UNITED STATES PATENT AND TRADEMARK OFFICE

APPLICATION NO.	FILING DATE	FIRST NAMED INVENTOR	ATTORNEY DOCKET NO.	CONFIRMATION NO.
10/030,818	06/07/2002	Hans Bruder	396/50809	2416

Office Action Summary

DETAILED ACTION

Claims 10-16 are rejected under 35 U.S.C. 102(b) as being anticipated by U.S. Patent 4410157 to Monti (see marked-up fig.3 below).

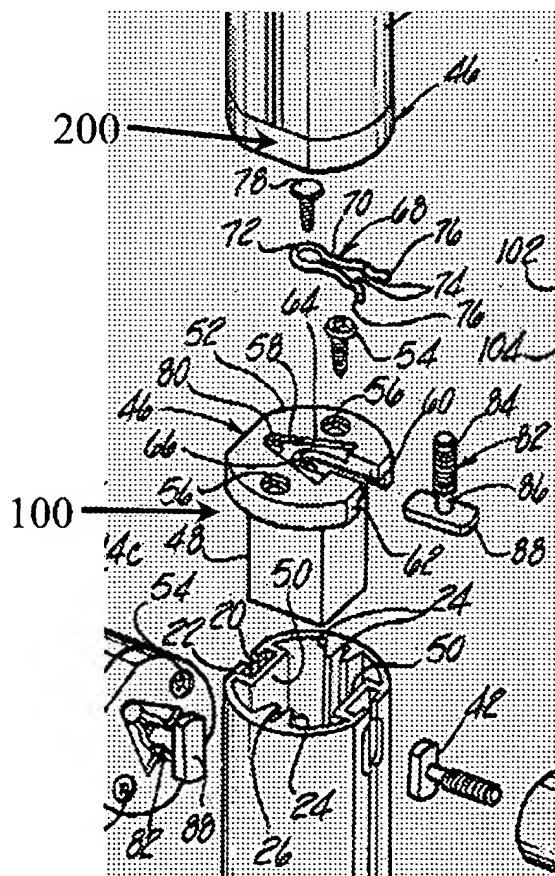
Claim 10. Monti discloses (fig.3) a supporting profile for erecting a structure, the supporting profile comprising: an elongated hollow body (14A) having first (top of 14A) and second (bottom of 14A) ends and a longitudinal groove (20) on the outside of the body; an adapter piece (100) inserted into and secured to the first end of the elongated body, the adapter piece having a receiving chamber (66); and a disk-shaped end piece (disc portion 200) disposed at the first end and connected (via 82) to the adapter piece, wherein the disk-shaped end piece is mounted (via 100) on a face (top face of 14A) of the hollow body and is fastened to the adapter piece by fasteners (68, 82, col.5, ll.20-26). The receiving chamber of Monti is fully capable of receiving a turnbuckle and thus meets the functional limitation “for receiving a turnbuckle”. It is well established that a recitation with respect to the manner in which an apparatus is intended to be employed, *i.e.* the functional limitation “for receiving a turnbuckle”, is given only limited patentable weight since it does not impose any structural limitation upon the claimed apparatus which differentiates it from a prior art reference disclosing the structural limitations of the claim. In re Pearson, 494 F.2d 1399, 181 USPQ 641 (CCPA 1974); In re Casey, 370 F.2d 576, 152 USPQ 235 (CCPA 1967); In re Otto, 312 F.2d 937, 136 USPQ 458 (CCPA 1963).

Claim 11. Monti discloses that the end piece has a concave recess (64) adapted (via 82) to an external curvature of a round profile.

Claim 12. Monti discloses that the end piece has an opening (66). The Monti opening is fully capable of having a turnbuckle pass through and thus meets the functional limitation “for the turnbuckle to pass through”.

Claim 14. Monti discloses that the joint includes a first disk (32) which extends perpendicular to the end piece and has a center bore (receiving 34), and a second disk (30) having a center bore (receiving 34) and being connected with the first disk by means of a bolt (34) extending through the center bores and acting as an axis of rotation, the second disk having a fastening device (12) for connection to another profile.

Claim 15. Monti discloses that the second disk is connected (via 12) to another end piece.

Claim 16. Monti discloses that the second disk has a clamping part (36, 38) that is configured (via 36) for insertion into longitudinal grooves of another supporting profile.

The applicant argues that the component (Top 52 [or 200 as it is referred to in the current office action]) belongs to profile (14B) and does not belong to profile (14A). This is not persuasive since the limitation “belongs to” is not recited in the claim language or the office action rejection. Rather, as claimed by the applicant, Monti discloses a disk-shaped end piece (disc portion 200 [Top 52 of the previous office action]) disposed at the first end (first end of 14A). The broadest reasonable interpretation of “disposed at” includes “being located near” and does not necessarily require “belonging to”.

The applicant argues that the element (top 52 [or element 200 as recited in the current office action]) is not mounted on a face of the hollow body (14A). It appears that the applicant assumes the limitation “mounted on” to necessarily require “direct contact between”. However, the broadest interpretation does not necessarily require this. For instance, a picture that is encased in a picture frame may be considered to be mounted on a wall even if the frame prevents direct contact between the picture and wall.
